ATTACHMENT D1

**Uranium One ISR Wellfield Hydrologic Impact Analysis
(Response to RAI 56)**

RAI 56

POTENTIAL IMPACTS FROM IRRIGATION WELL SMITH #1

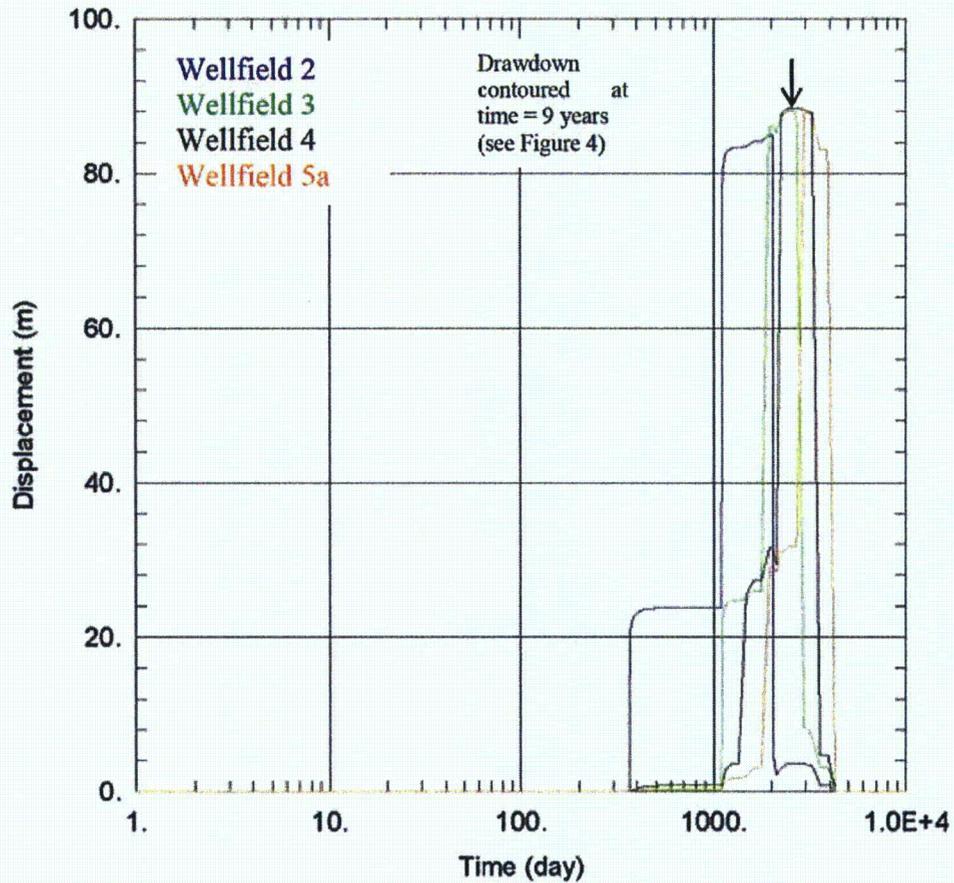
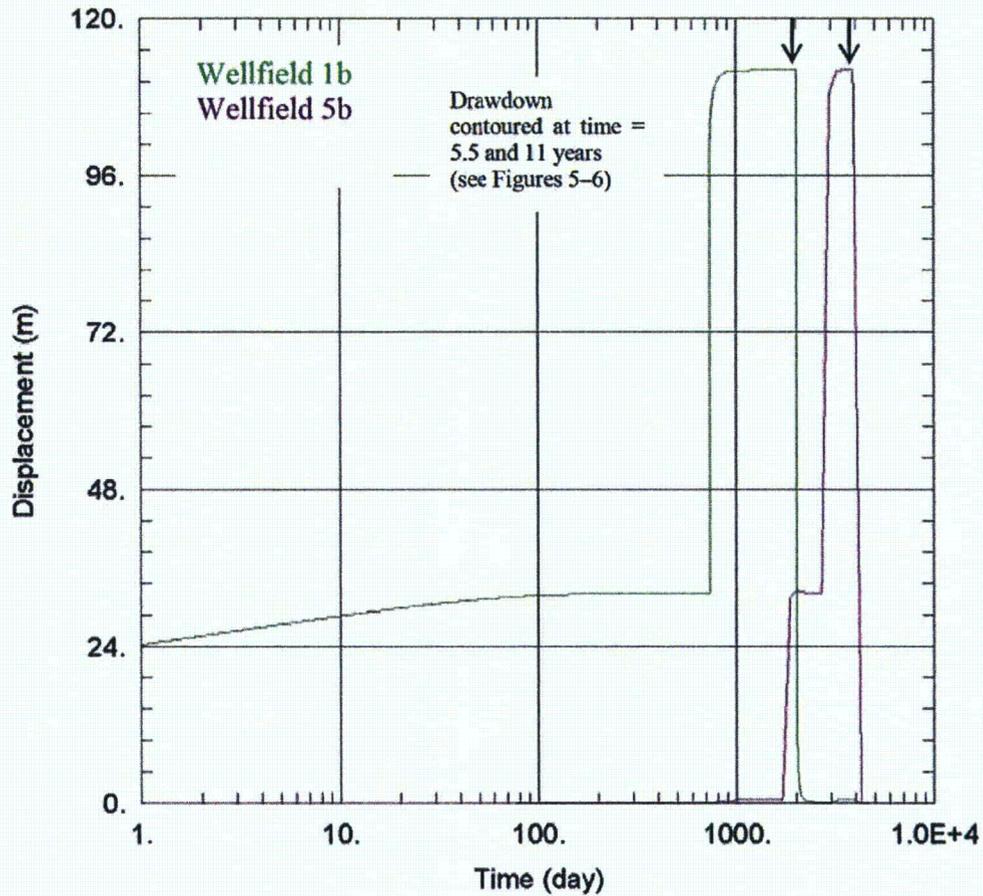
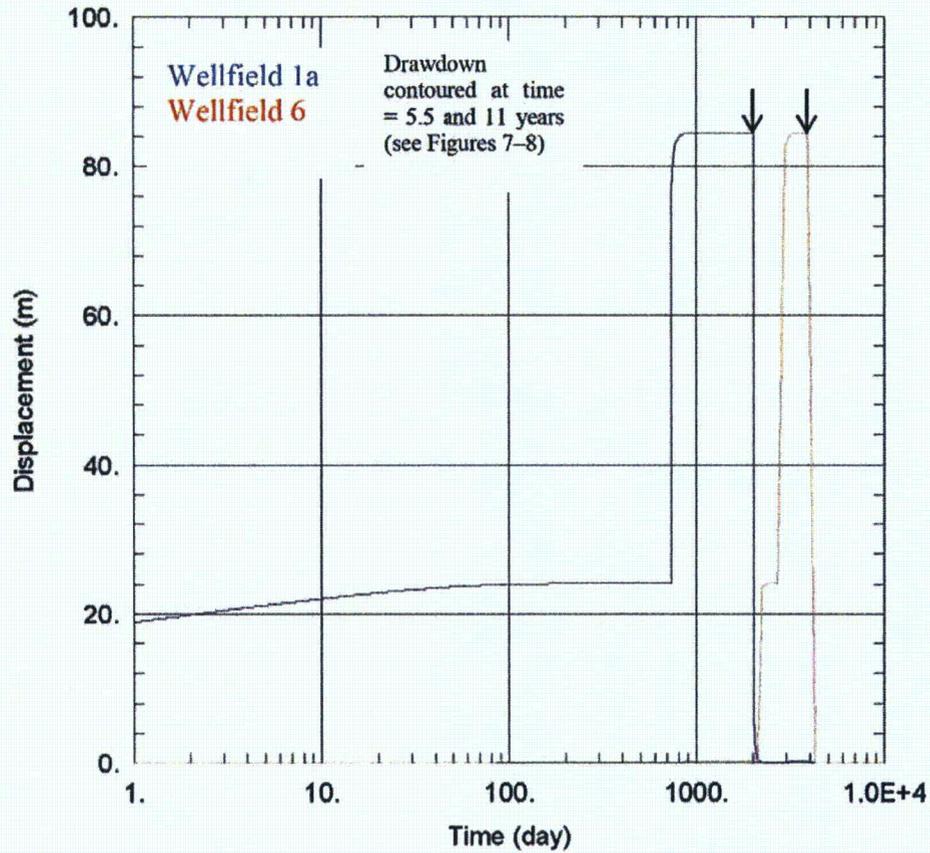
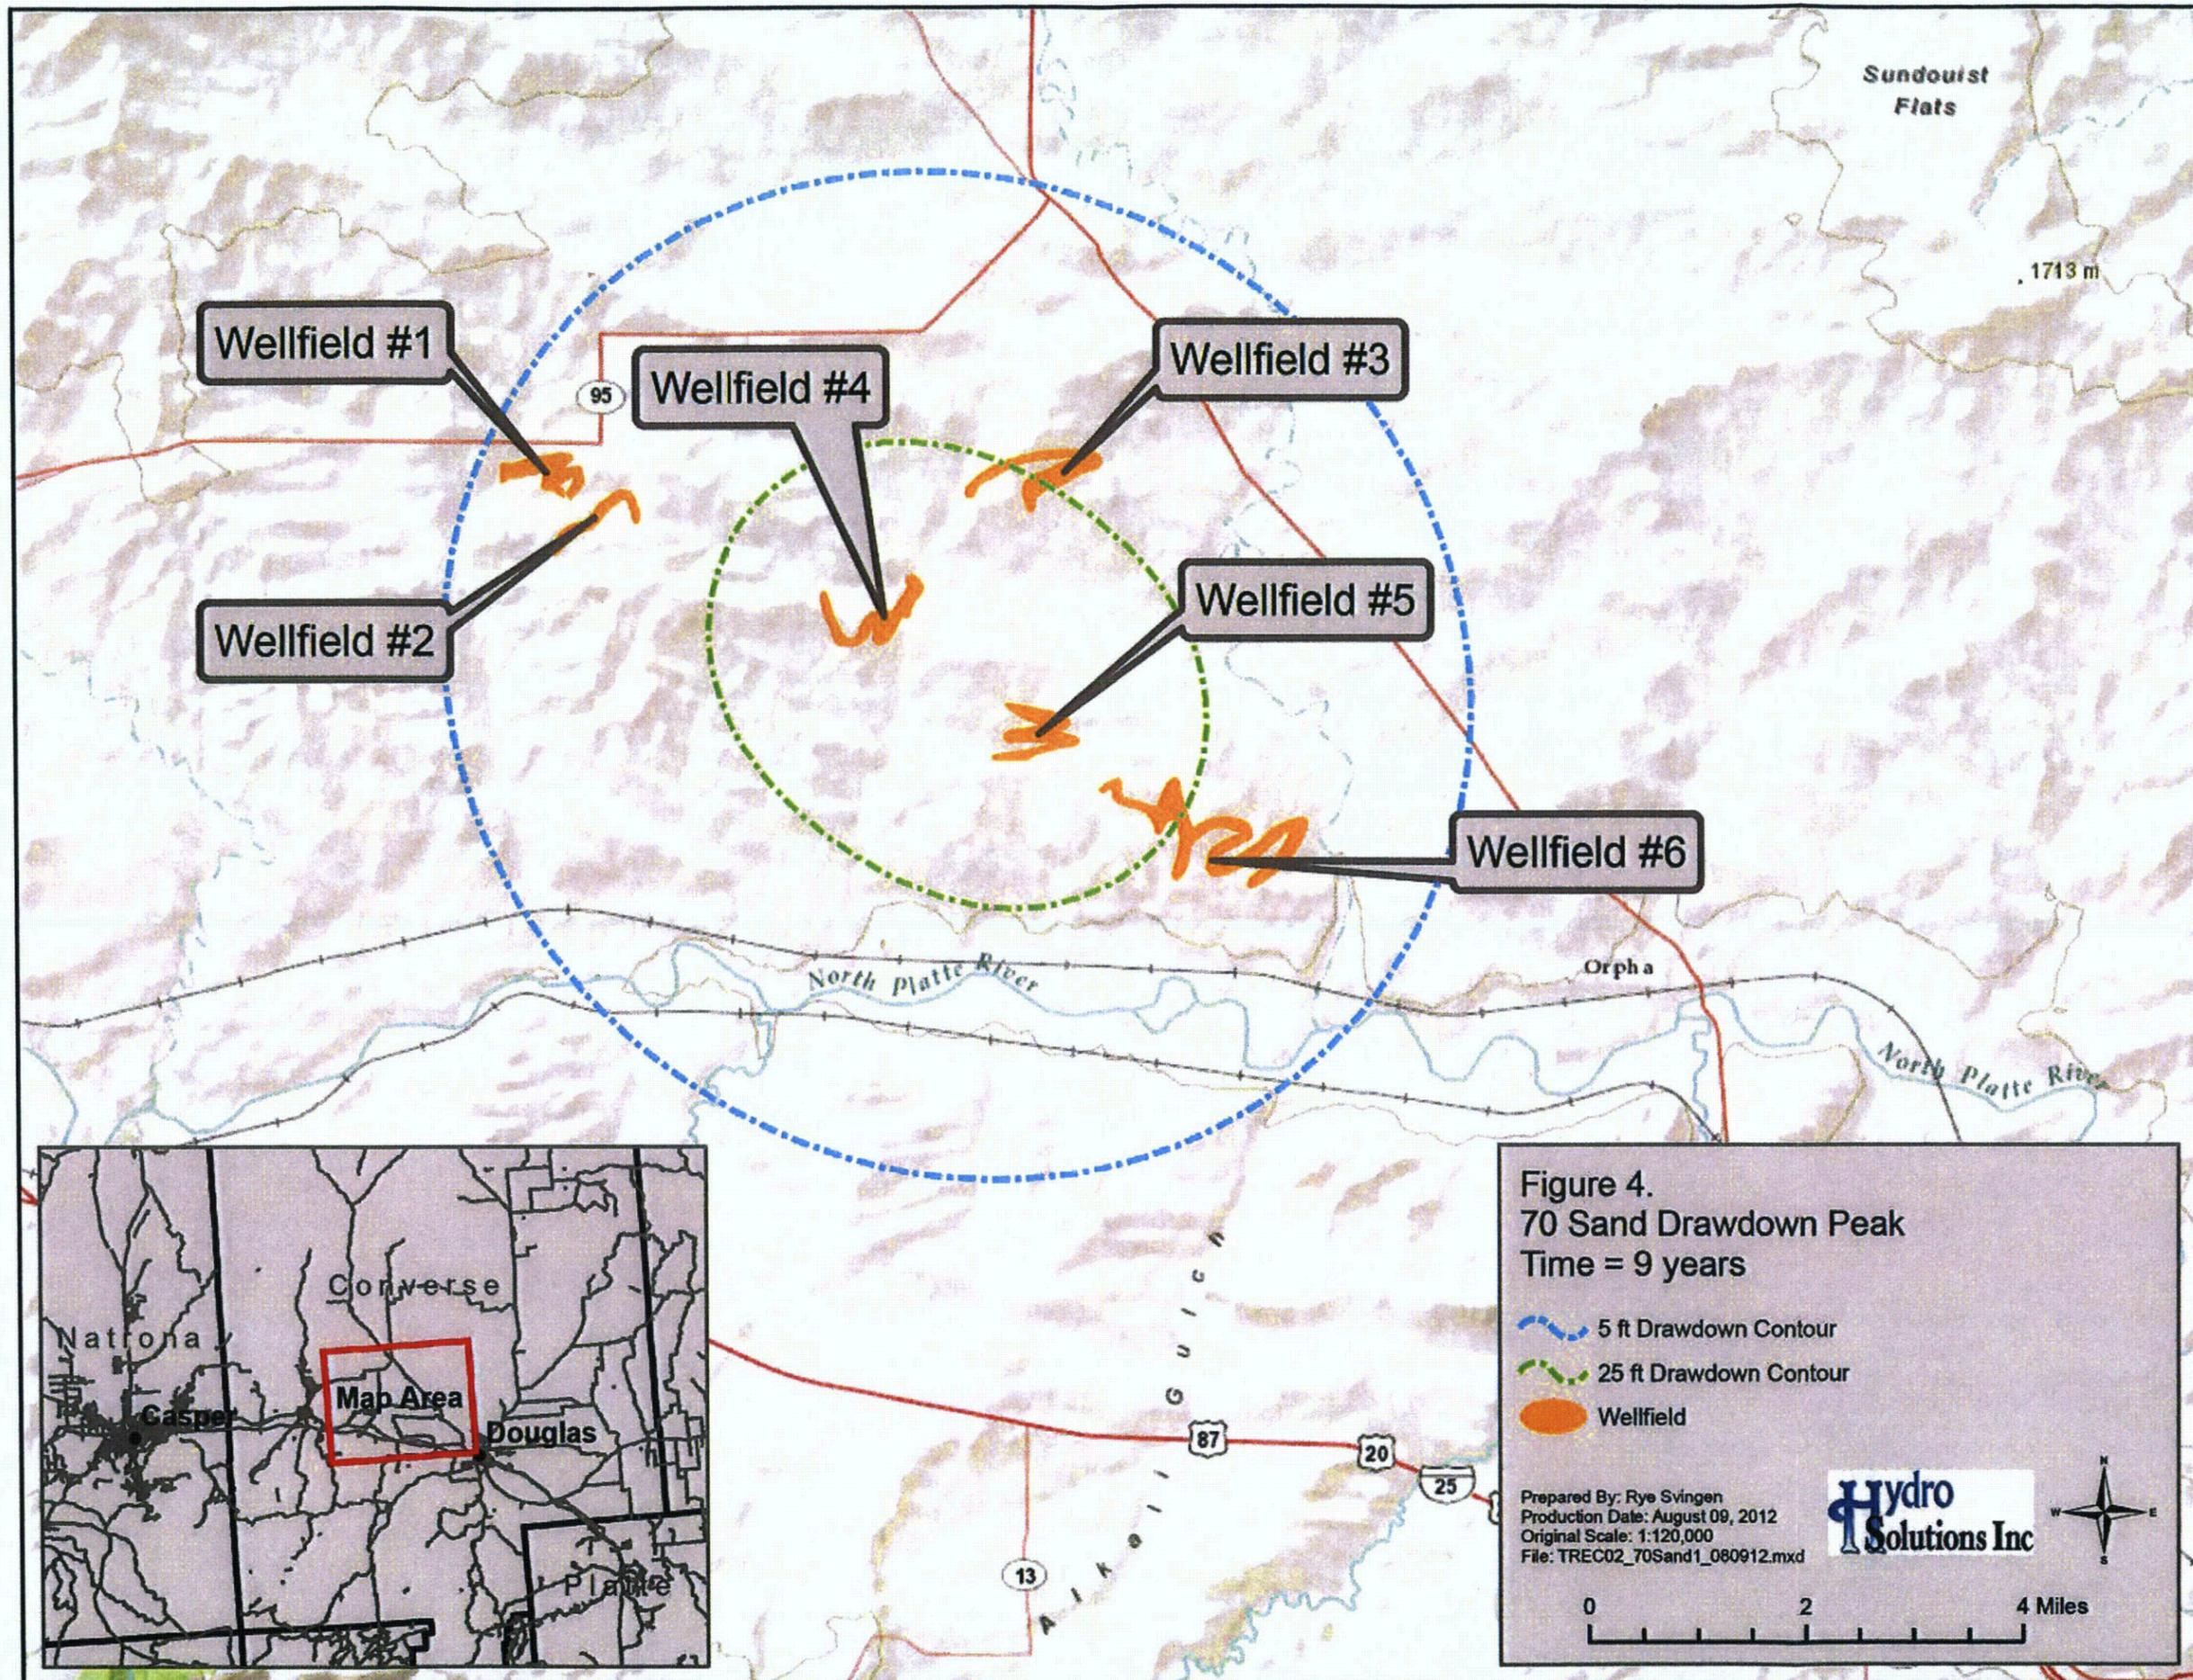
TR Section 3.1.6.1 provides the ROI for the 90 sand, 80 sand, and 70 sand as 550 ft, 500 ft, and 750 ft, respectively, based on the aquifer pumping tests. The TR also states there would be no impact to groundwater levels outside the project boundaries based on these estimates for the proposed bleed rate (15-45 gpm). These ROI were derived based on observations during the aquifer testing of these sands but the TR provided no calculations to support these numbers. Staff does not agree with Uranium One's definition of ROI. In practice, the ROI is defined by a function of transmissivity (T), time (t) and storage coefficient (S) in consistent units (Bear, 1979).

Staff requires the ROI and drawdown which will be realized at each satellite to assess the impacts of consumptive use on surrounding private wells and to provide reasonable assurance of the safe operation of the satellites.

Uranium One should provide: (a) the ROI using the estimated T, S and the time of production and restoration for each satellite wellfield; and (b) a prediction of the drawdown for each satellite wellfield within 2 km for each phase of operation using the appropriate consumptive use (e.g. 15-45 gpm).

A Theis-based analytical drawdown model for the 70, 80 and 90 Sand units at the proposed project was completed using site-specific aquifer parameters. The production sands of the Ludeman Project satisfy the assumptions required by the Theis model to the extent generally accepted for this type of hydrogeologic evaluation. Project-specific assumptions and limitations have been noted and discussed in this Memorandum. Model inputs were entered into AQTESOLV software, and graphs were produced showing the predicted time-drawdown behavior of the proposed project wellfields. Drawdown contour

Drawdown contours produced by the model were typically circular to somewhat elliptical in shape, depending on the distribution of active pumping centers in a given aquifer. At the time(s) of maximum drawdown, 25 foot drawdown contours for the 70, 80 and 90 Sand units had maximum radii that ranged between about 1.2 to 2.4 miles from their approximate pumping centers (wellfields) at the Ludeman site. Five foot drawdown contours for the 70, 80 and 90 sands typically had radii of approximately 3.4 to 4.8 miles from the pumping centers. A summary of approximate radial distances to the five and 25 foot drawdown contours for each aquifer is presented on Table 5.

Graphs showing the modeled time-drawdown characteristics of the pumping centers in each aquifer over the duration of the project are presented on Figures 1–3. Results of the analytical drawdown modeling are also presented as drawdown contour maps on Figures 4–8. Due to the operational schedules of the 80 and 90 Sand units, two distinct drawdown peaks were noted in the model output, which correspond to unique areal drawdown patterns. Thus, individual contour maps were prepared for both the first and second peaks in these cases.
